SOLICITATION AMENDMENT
MODIFICATION DE L'INVITATION

Title - Sujet MSVS - SMP Vehicles	
Solicitation No. - N° de l'invitation W8476-06MSMP/L	Amendment No. - N° modif. 008
Client Reference No. - N° de référence du client W8476-06MSMP	Date 2013-11-01
GETS Reference No. - N° de référence de SEAG PW-\$\$BW-008-23908	
File No. - N° de dossier 008bw.W8476-06MSMP	CCC No./N° CCC - FMS No./N° VME
Solicitation Closes - L'invitation prend fin at - à 02:00 PM on - le 2013-12-17	Time Zone Fuseau horaire Eastern Daylight Saving Time EDT
F.O.B. - F.A.B. Plant-Usine: <input type="checkbox"/> Destination: <input checked="" type="checkbox"/> Other-Autre: <input type="checkbox"/>	
Address Enquiries to: - Adresser toutes questions à: Lortie, Yves	Buyer Id - Id de l'acheteur 008bw
Telephone No. - N° de téléphone (819) 997-7268 ()	FAX No. - N° de FAX (819) 997-0786
Destination - of Goods, Services, and Construction: Destination - des biens, services et construction: See Herein

Standard Military Pattern (SMP) Vehicles

Amendment # 8

SCHEDULE BA-3-1 – ELECTRONIC EQUIPMENT INSTALLATION FOR VEHICLE NOT DESIGNED
TO ACCEPT APS

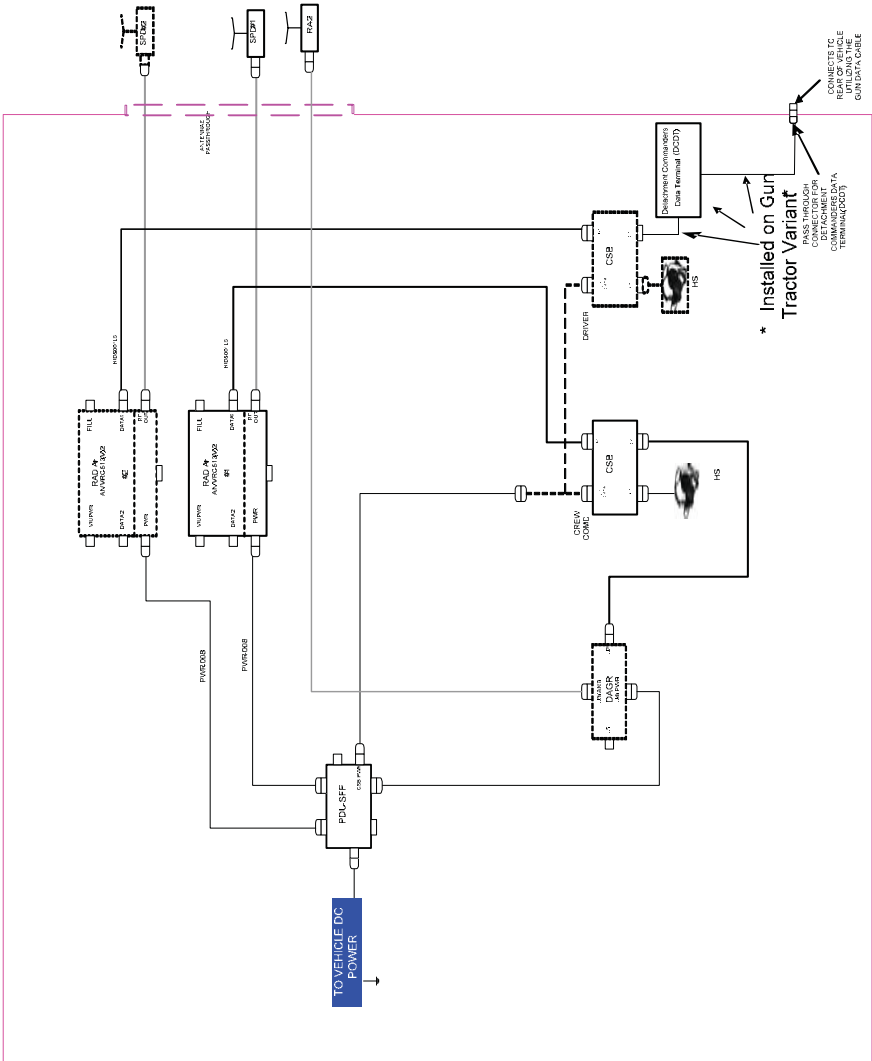
2. At Part 7, Annex B - Statement of Work, Appendix BA, Attachment BA-3, Schedule BA-3-1 - Electronic Equipment Installation for Vehicle Without APS

Delete: In its entirety

Insert: Schedule BA-3-1 - Electronic Equipment Installation for Vehicle Not Designed To Accept APS - Revision 1 (see attached)
